## Reed Block Gasket – Mariner/Mercury 100/115

Figure 1.

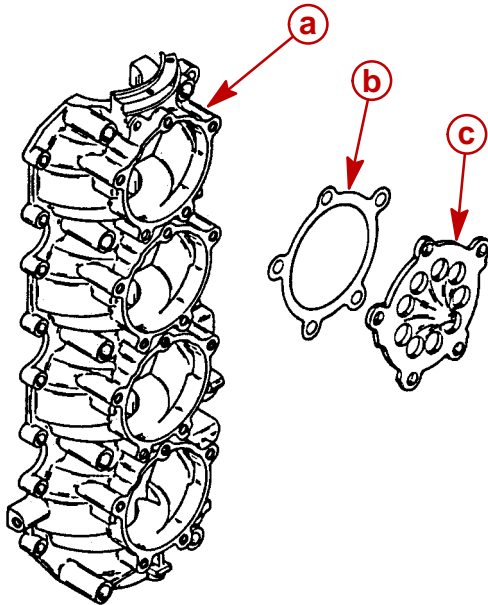
Outboards listed may have more than one gasket installed between the reed block and crankcase. (Figure 1) Due to production changes, we have returned to installing only one gasket.

When servicing these outboards, install only one gasket P/N 27-13937--2, --4 or --6 between all reed blocks and the crankcase.
